**SEISMIC STABILITY EVALUATIONS OF CHESBRO,
LENIHAN, STEVENS CREEK, AND UVAS DAMS
(SSE2)**

ADDENDUM TO WORK PLAN

TERRA / GeoPentech
a Joint Venture

ADDENDUM TO WORK PLAN FOR SITE INVESTIGATIONS AND LABORATORY TESTING AT STEVENS CREEK DAM

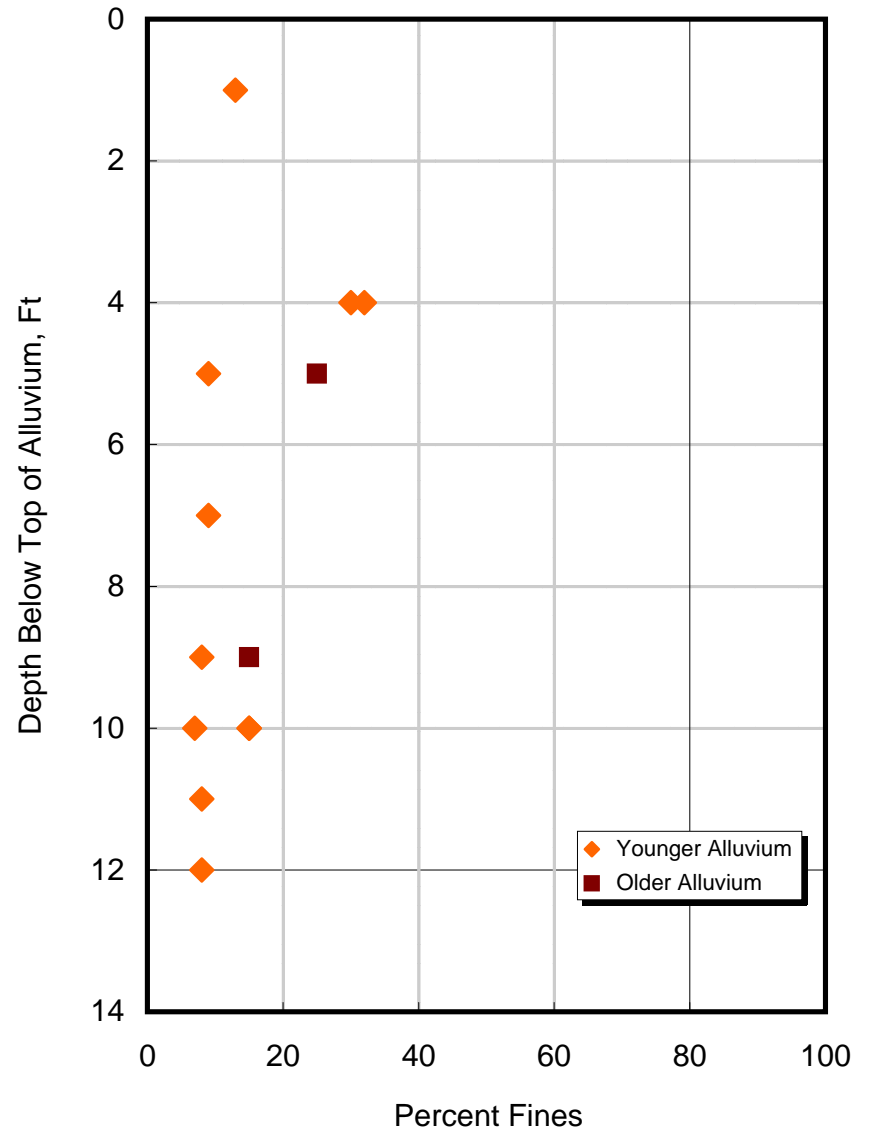
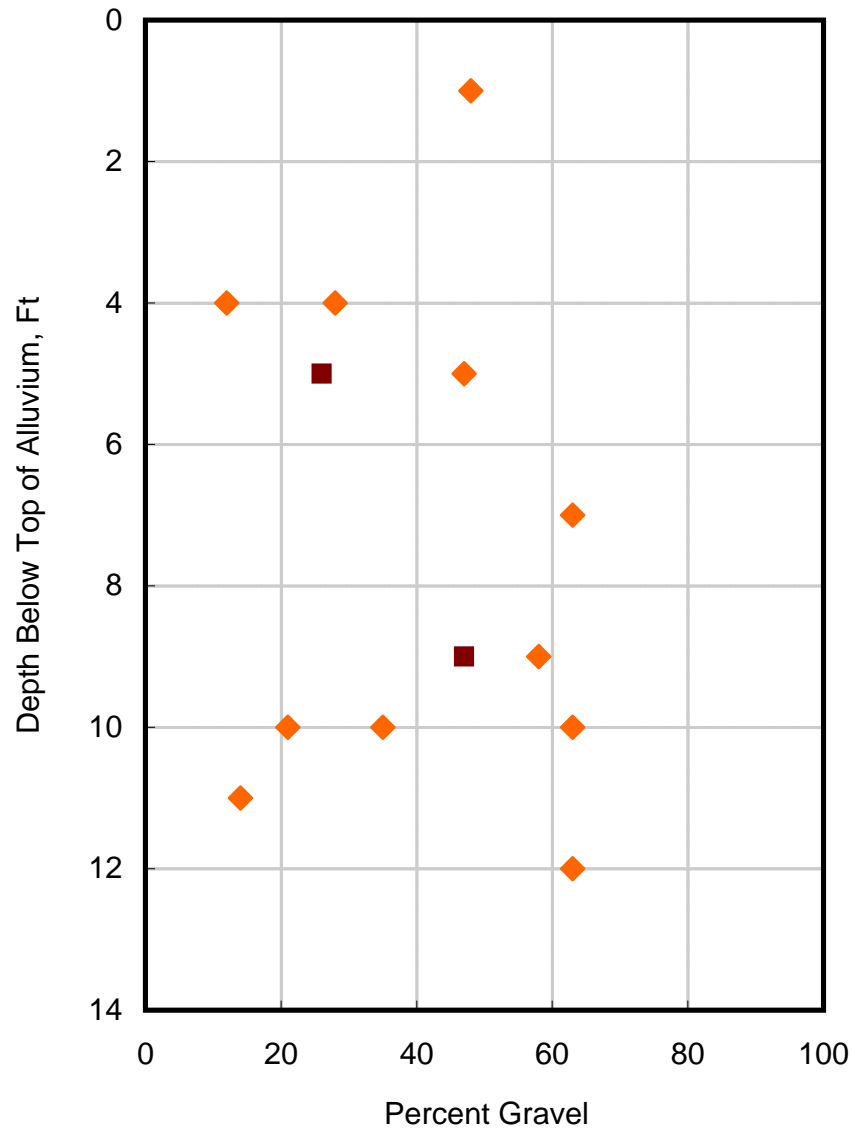
THREE 40-FT DEEP BECKER BORINGS ADDED:
 • 1 10 FT FROM SC-104MR AND 2 AS SHOWN
 • SEALED OBSERVATION WELLS INSTALLED IN BORINGS SC-106 BB AND SC-107 BB

15-FT X 60-FT WORKING PLATFORM (LEVEL)
 12-FT WIDE TEMPORARY ACCESS ROAD (3.2 : 1 SLOPE)
 REPLACED MUD ROTARY BY BECKER BORING

15-FT WIDE WORKING PLATFORM (LEVEL)
 12-FT WIDE TEMPORARY ACCESS ROAD (3.6 : 1 SLOPE)
 REPLACED MUD ROTARY BY BECKER BORING

1. Delete mud rotary borings SC-102MR, and SC-103MR.

- d. measuring shear wave velocities of the original embankment, alluvium and Santa Clara Formation using OYO downhole suspension logging.
3. Add five Becker Penetration Test borings, one each at the location of borings SC-102, SC-103, and SC-104, and two additional Becker borings located 50 feet on either side of Boring SC-104.

4. Install four grouted-in-place vibrating wire piezometers in Becker Boring SC-102 as shown on Figure 10R.
5. Install two sealed 2-inch diameter observation wells within the Becker borings SC-106BB and SC-107BB that are located 50 feet on either side of Boring SC-104BB.

Sealed observation wells will be installed upon completion of Borings SC-106BB and SC-107BB, as shown on Figure 9R. The procedure for installing the observation wells is described in the following subsection.

Figure
 10R

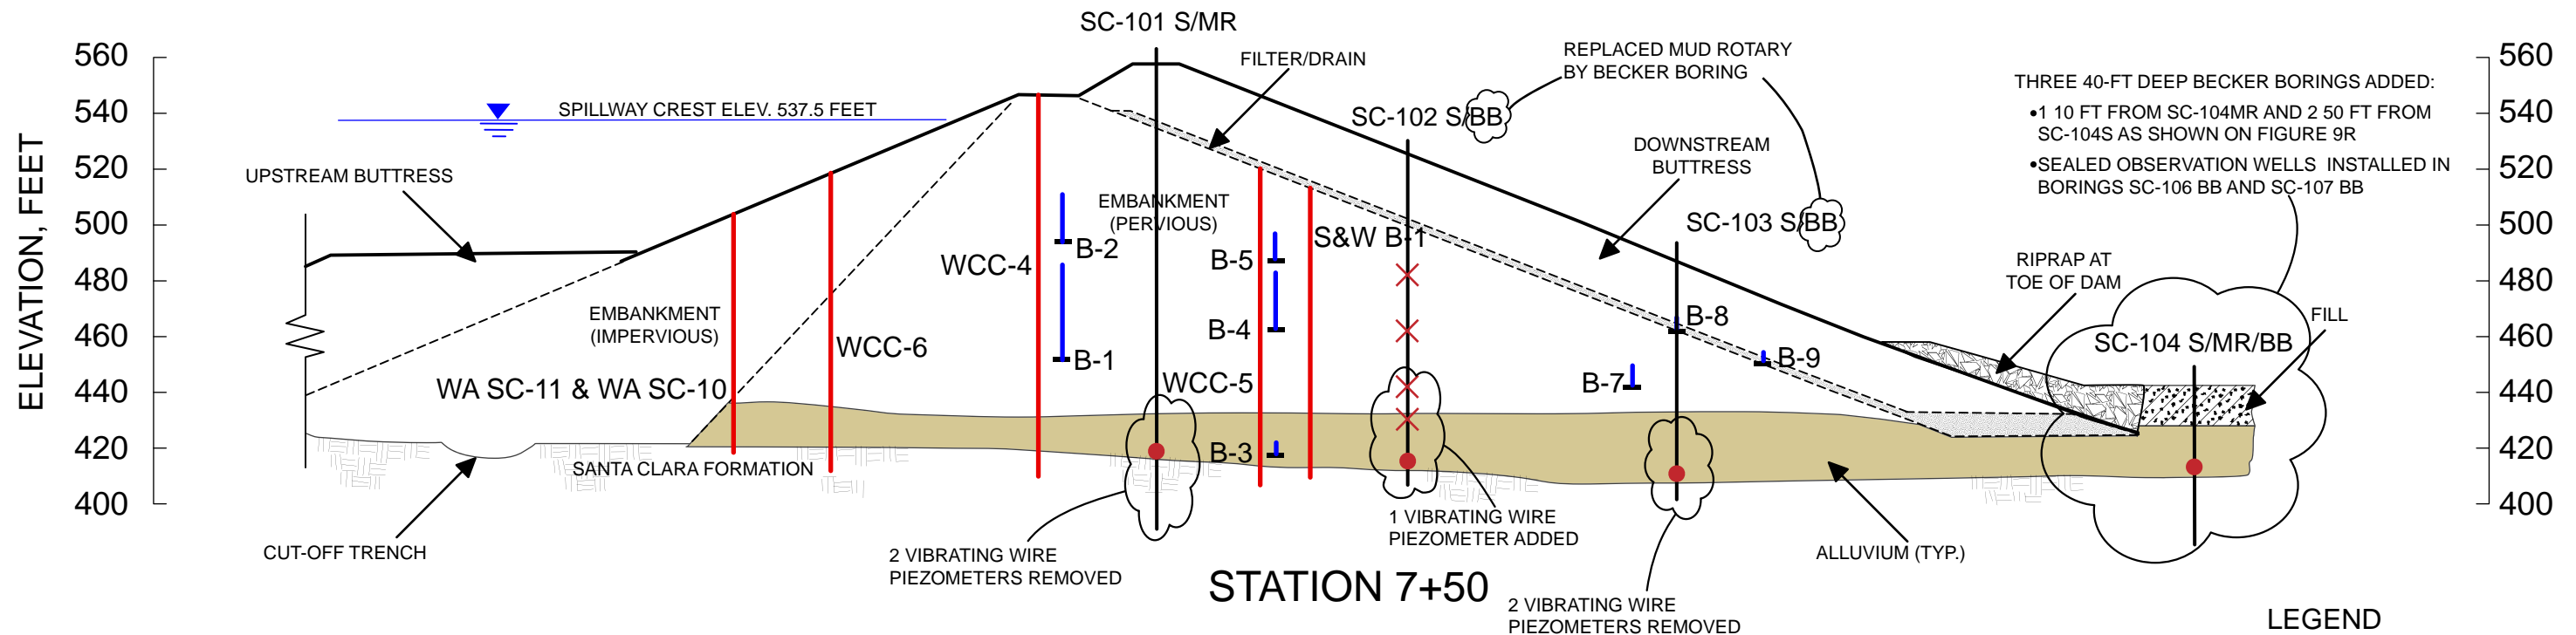
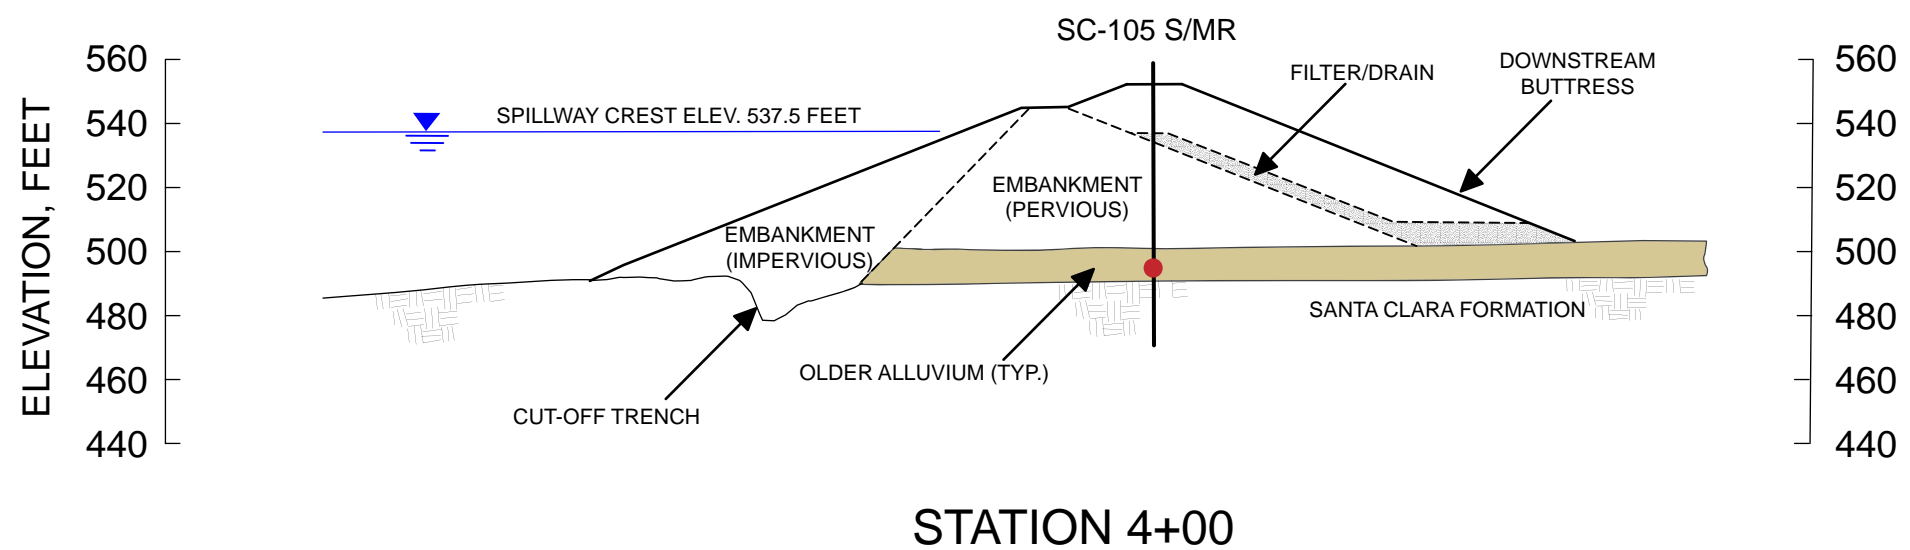
THREE 40-FT DEEP BECKER BORINGS ADDED:
 • 1 10 FT FROM SC-104MR AND 2 50 FT FROM SC-104S AS SHOWN ON FIGURE 9R
 • SEALED OBSERVATION WELLS INSTALLED IN BORINGS SC-106 BB AND SC-107 BB

Boring SC-102BB will be completed by installing 4 multi-level vibrating wire (VW) piezometers as shown on Figure 10R. The procedure for installing these piezometers is described in Section 11.2 of the Work Plan, except that the installation procedure will be modified so that the string of vibrating wire piezometers (and associated placement pipe) is installed inside the Becker drill casing after the plug at the bottom of the casing has been removed or knocked out.
